Site Accessibility Evaluation

**Work Net Office Building
Suites 102-133**

**543 W Grant Line Rd
Tracy, CA 95376**

Inspection Date: 11/14/2016

Finding: 30

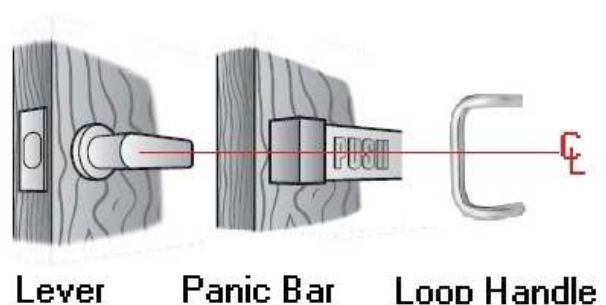
The operating hardware is not accessible because it requires tight grasping, pinching or twisting of the wrist to operate.

Key required

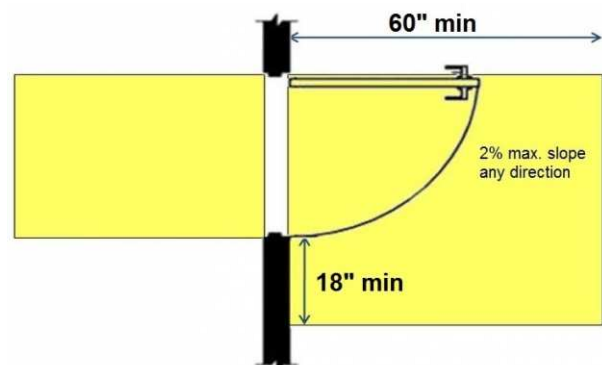
53" (obstructed by trash can)

Remove/relocate trash can out of the required door maneuvering clearance.

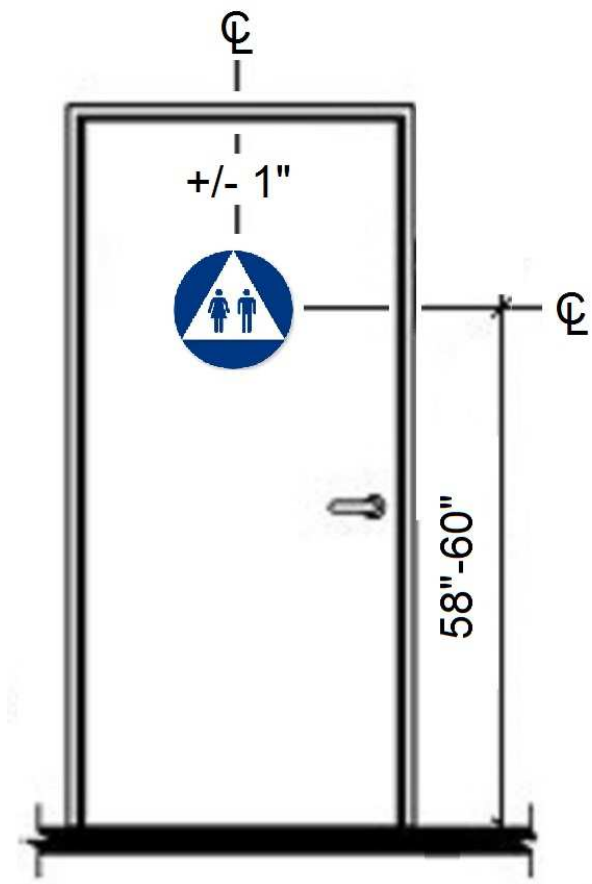
61 3/4"

Relocate the sign to correct height.

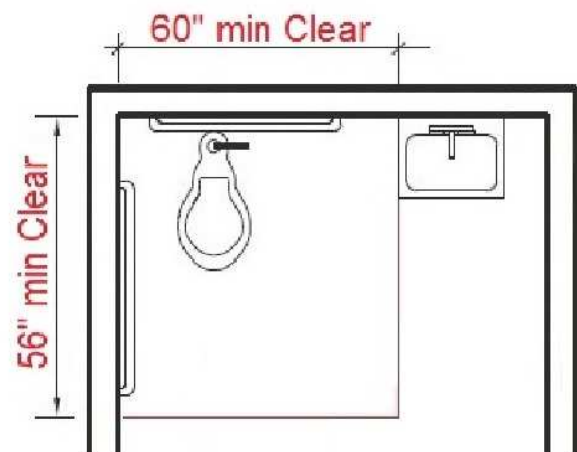
57" (60" Req.)

Relocate the lavatory to the adjacent side wall a minimum 18" to the centerline of the lavatory off sidewall or provide a smaller lavatory that does not encroach into the the required 60" clear floor space for the toilet. Services of a Licensed Architect, Registered Engineer or Licensed Contractor may be required.

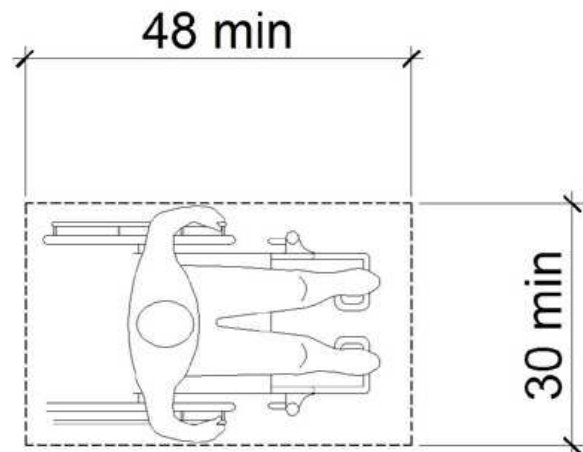
Obstructed by drain
pipe from roof.

Remove drain pipe out of the required lavatory clear floor space. Typically these condensate drain lines are up at ceiling height and do not obstruct the lavatory clear floor space or lavatory controls.

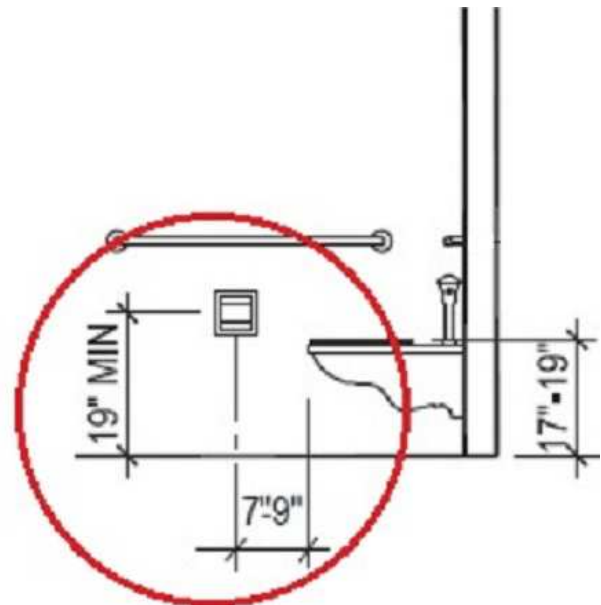
5 1/2" (toilet front)

Relocate/remount toilet paper dispenser to correct location.

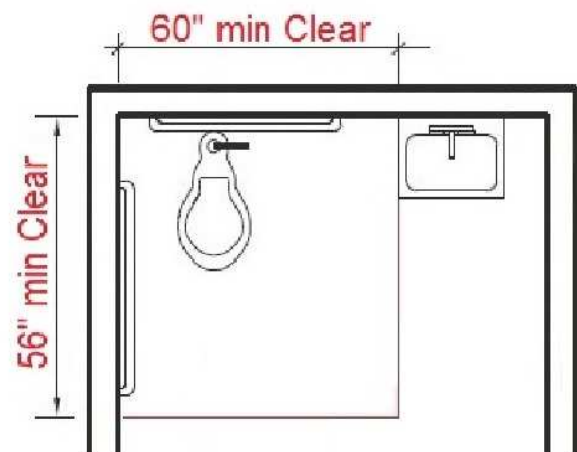
57" (60" Req.)

Relocate the lavatory to the adjacent side wall a minimum 18" to the centerline of the lavatory off sidewall or provide a smaller lavatory that does not encroach into the the required 60" clear floor space for the toilet. Services of a Licensed Architect, Registered Engineer or Licensed Contractor may be required.

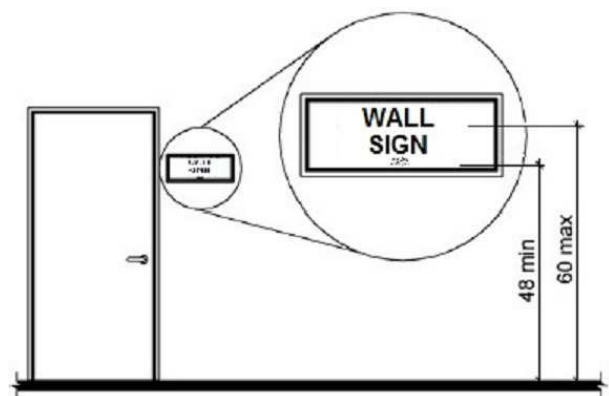
Missing Tactile "Data Room: wall sign

Add compliant tactile and braille wall sign for "Data Room" as specified or remove "Data Room" sign from the door.

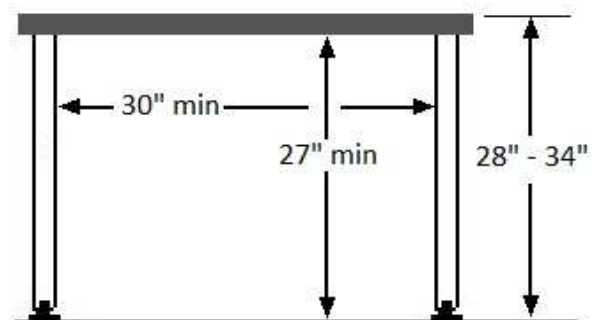
Single pole table, no
knee toe space.

Replace table with a 4 leg table and clearances/heights as specified.

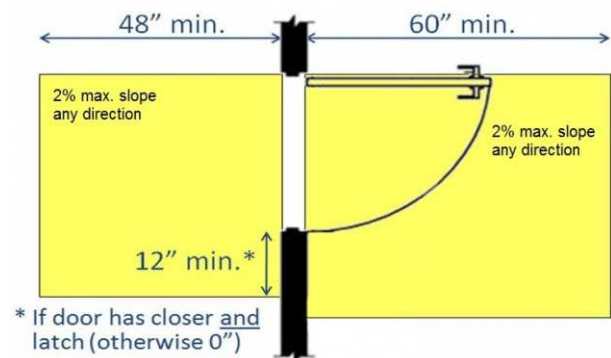
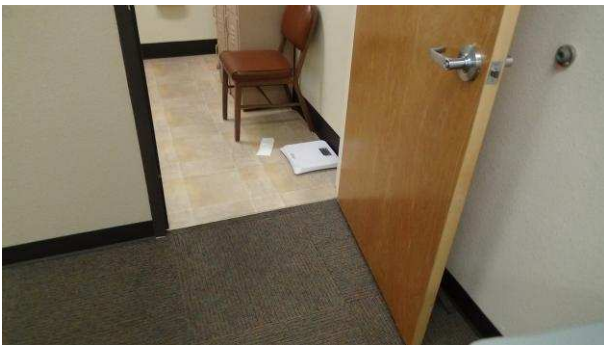
Lockers, chair and scale obstruct door and turning clearances inside the restroom.

Remove the lockers, chair, and scale from the restroom.

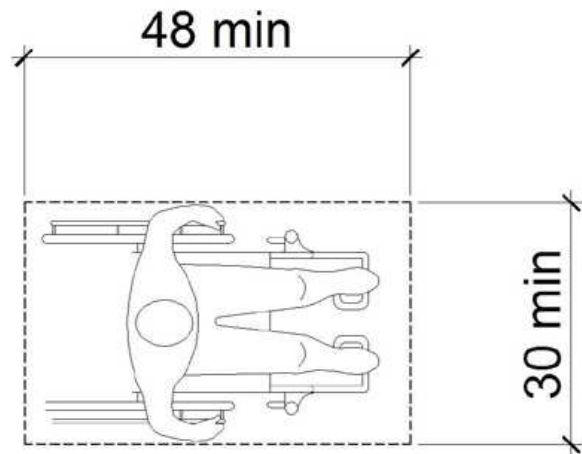
Obstructed by lockers

Remove lockers and other obstructions from the restroom.
